AUBURN HILLS 5TH ADDITION

Re: S/D97-84 -- Final Plat of AUBURN HILLS 5TH ADDITION

STAFF REPORT

CASE NUMBER: S/D 97-84 AUBURN HILLS 5TH ADDITION
OWNER/APPLICANT: West Wichita Development Inc., Jay Russell, 12602 W. 13th St. West, Wichita, KS 67235

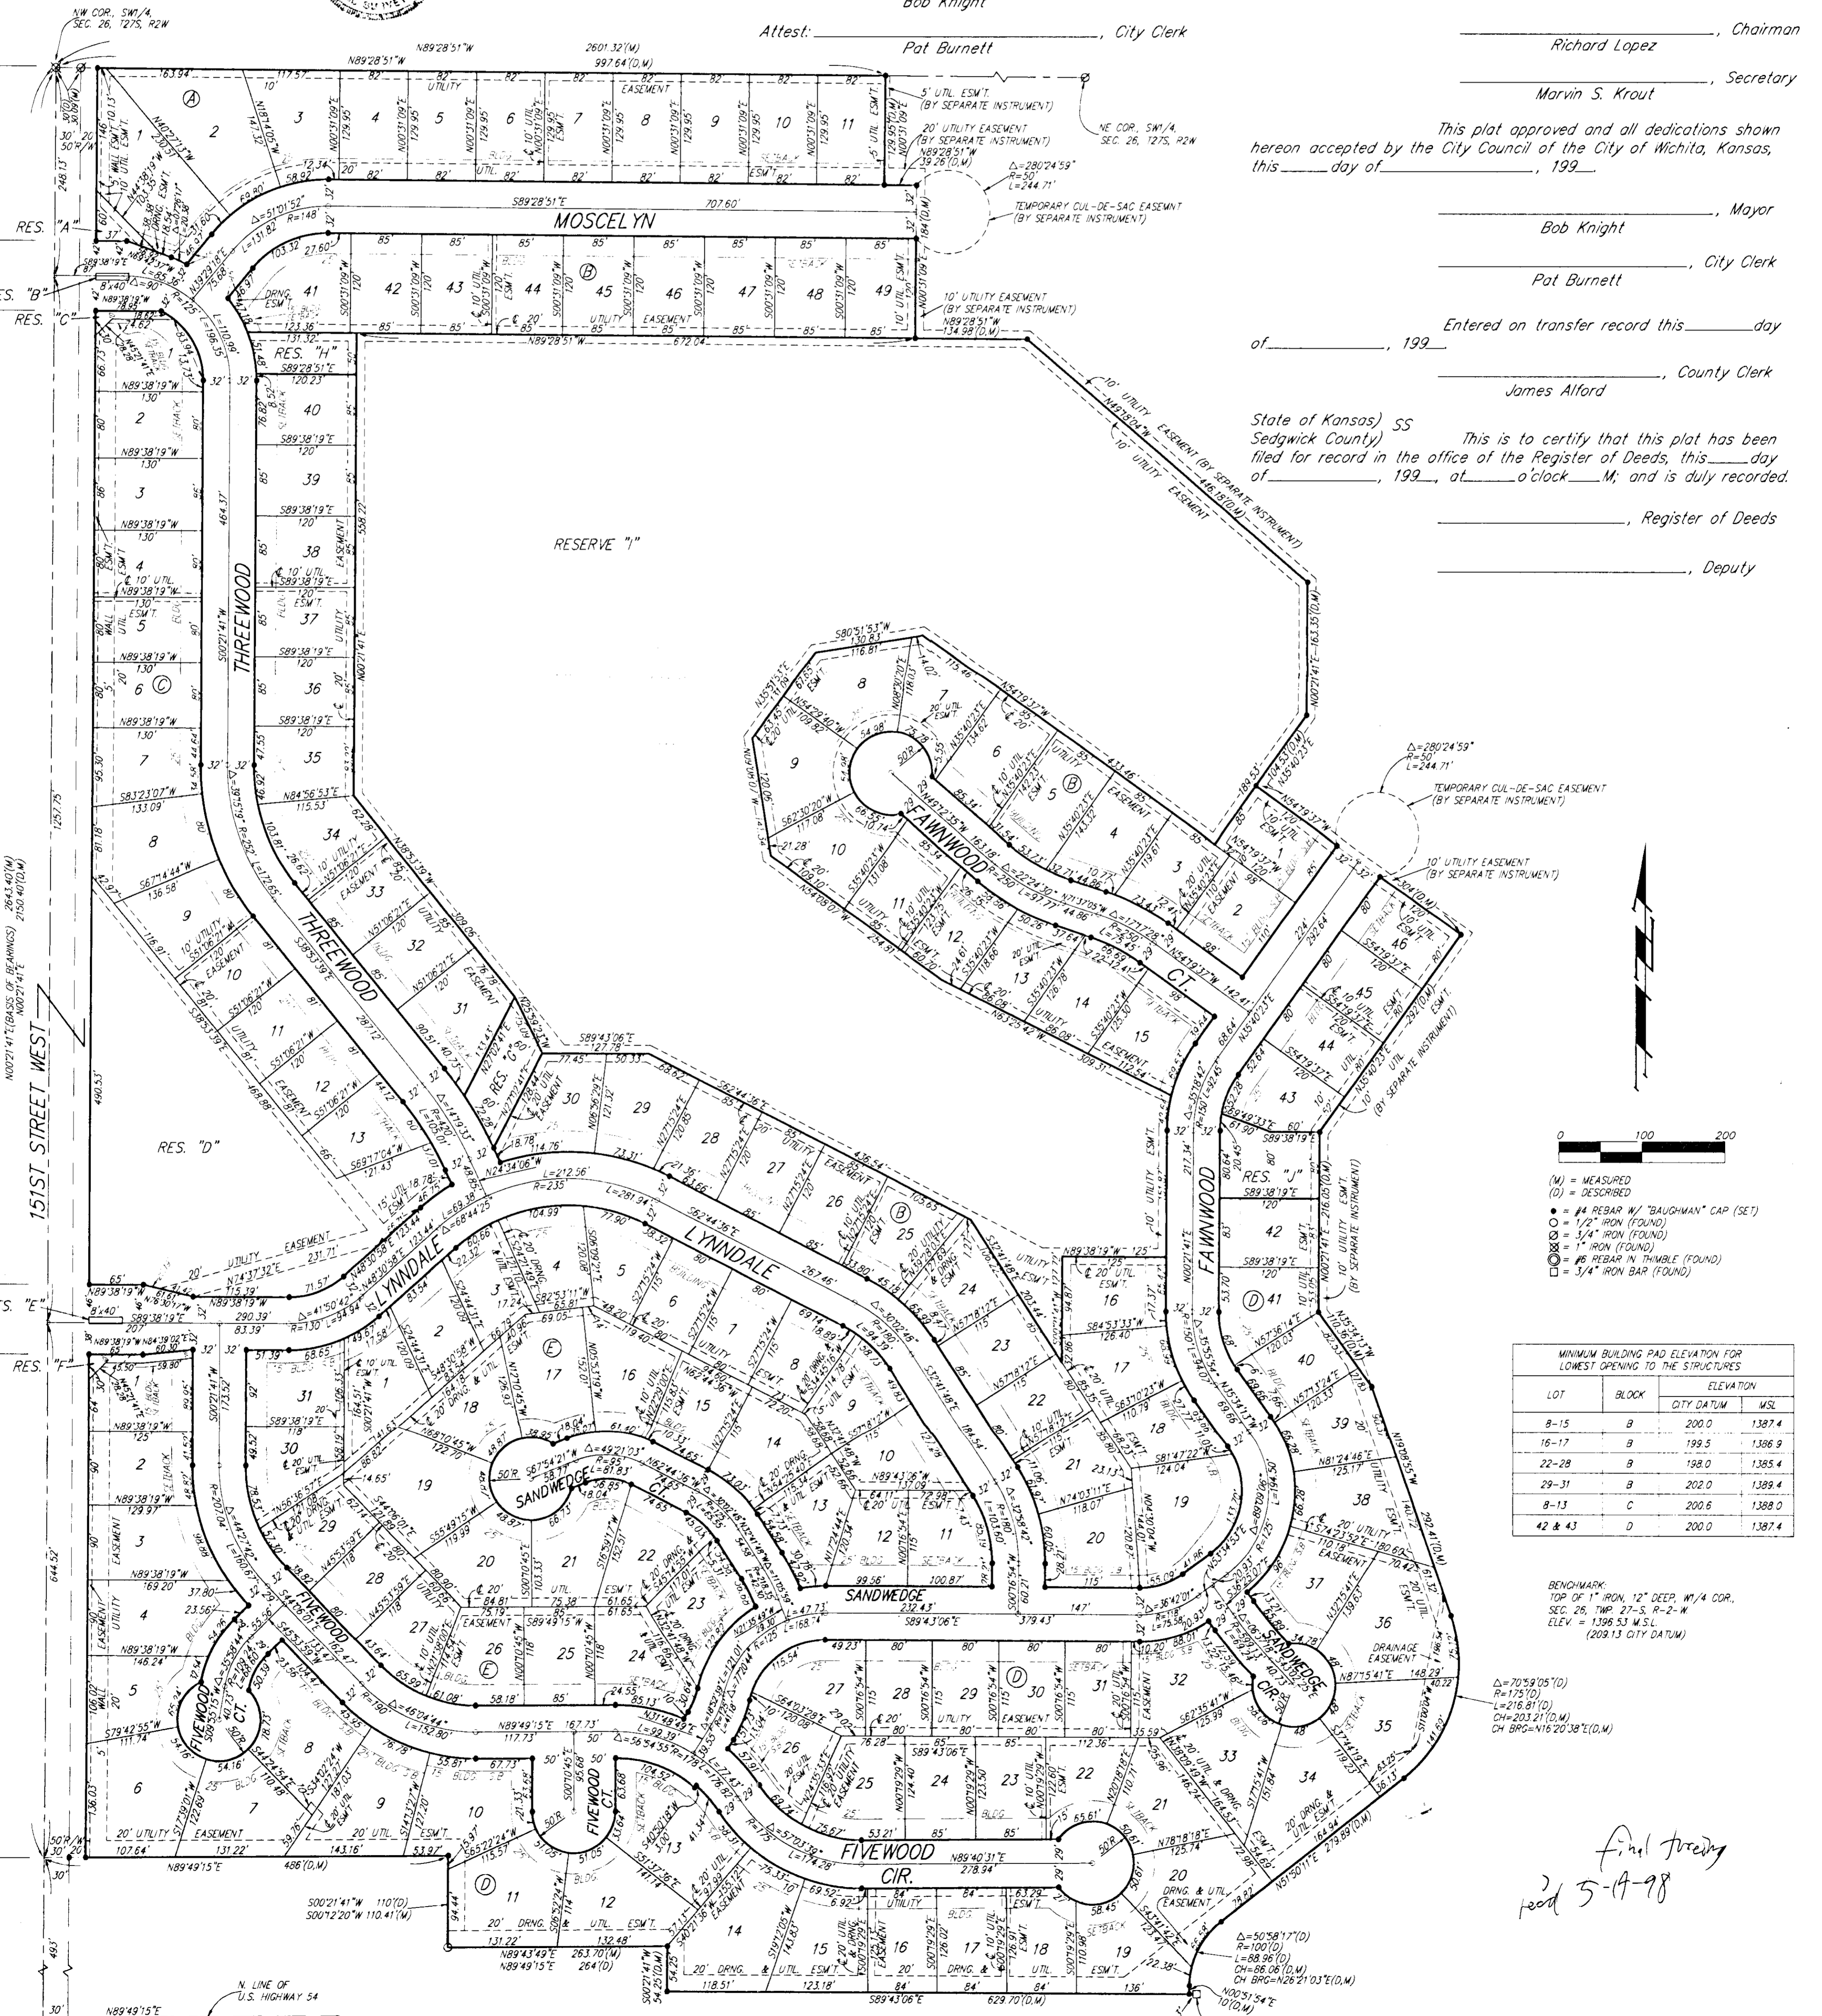
- A. ✓ Prior to this plat being scheduled for City Council review, annexation of the property will need to be completed.
- B. ✓ City Engineering needs to indicate the status of Wichita water and sanitary services for this area and what guarantees need to be provided at this time. An off-site utility easement will be required for the extension of sanitary sewer. A 10-foot off-site utility easement will also be required for Lots 38 through 48 in Block 4.

- E. A street stub to the north of this plat should be shown for connection to potential future development.

The final plat does not indicate the street stub to the north, as requested during preliminary plat review. However, the preliminary plat submitted for Auburn Hills 6th Addition indicates a street stub to the north adjoining the northeast corner of this plat.

- F. Distances should be shown for all segments of access control. On the final plat tracing, since the site will be within Wichita City limits upon annexation, the plat's text shall note that the access controls are being dedicated to the "City of Wichita".

- I. The applicant needs to revise the legal description on the face of the plat to accurately portray the land being platted. The distances and degrees adjoining lots 11 and 12 on the southern line of the property need to be included in the plat's text. In addition, several southern bearings on the face of the plat need to be corrected to reflect northern bearings as identified in the legal description.

- J. Temporary turnarounds will be needed for the terminus of Fawnwood and Onewood Streets. On the final plat, the area for temporary turnarounds should be shown with dashed lines around the area of the actual street.

The plat's text should indicate that the temporary turnaround areas will automatically be vacated upon the extension of the streets.

The KG&E representative requested a 10-foot utility easement adjoining the right-of-way between Lots 15 and 16 in Block B which has not been denoted on the final plat.

KGE has requested additional easements as denoted on the attached plats.
